Charlotte Historic District Commission Application for a Certificate of Appropriateness

ADDRESS OF PROPERTY	2019 Park Road, Dilworth Local Historic District	HDC 2011-064
SUMMARY OF REQUEST	Addition of Two Hipped Dormers Enclosure of Existing Screened Porch	
OWNERS	Katherine Prater	
APPLICANT	Allen Brooks, Architect

FRONT ELEVATION

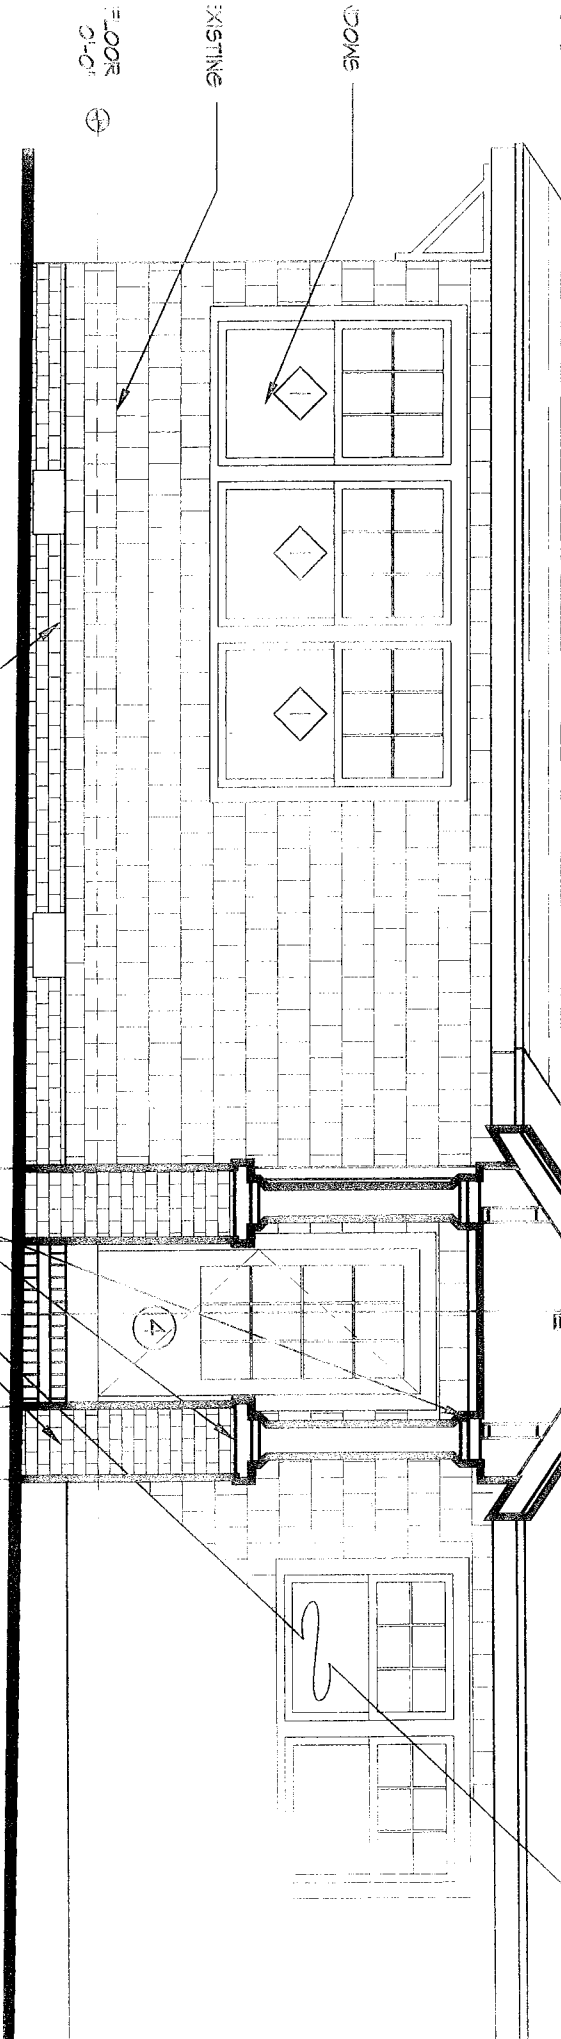
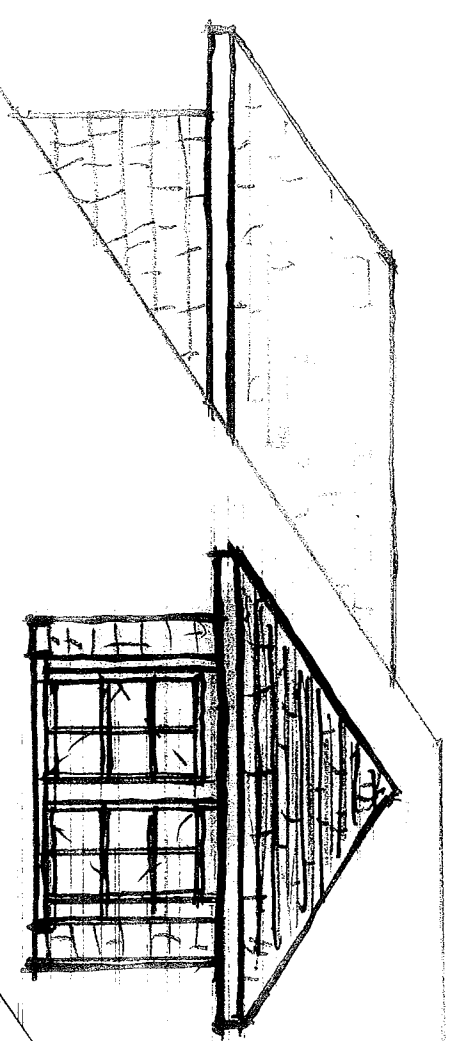
Not mentioned in the application but shown on the drawings is the replacement of a small wood louvered attic vent on the façade of the house with a new window. The window is noted as the egress window for the new bedroom.

REAR ELEVATION

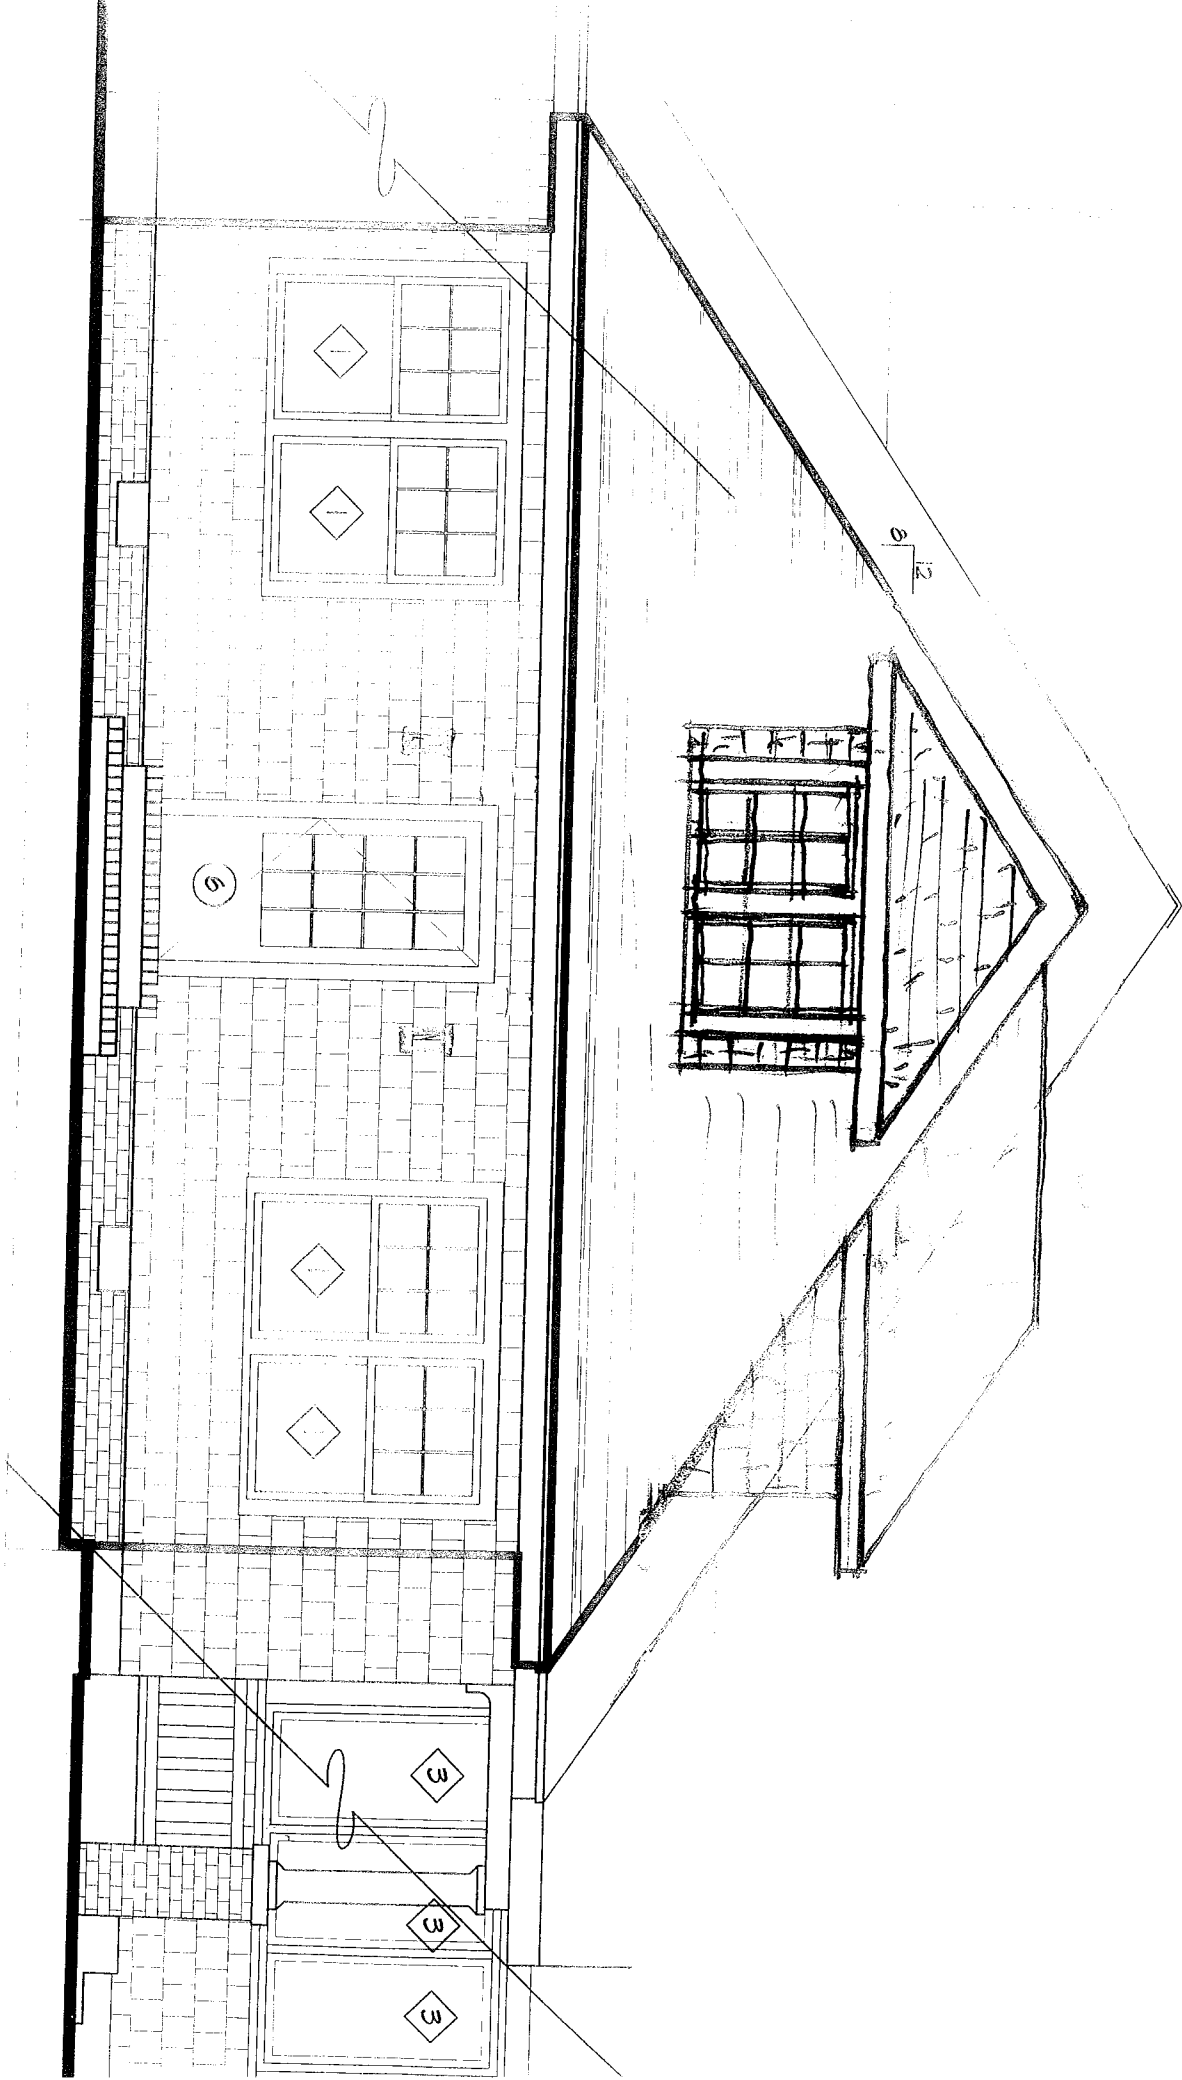
The attached plans, which are rough and somewhat hard to interpret, show the addition of two small hipped dormers at the rear of this house. One of the new dormers would face to the rear of the house, and the other would face the driveway on the left side of the house. The design of the dormers appears to be appropriate to the style of the house, with shingle siding and trim matching the existing house.
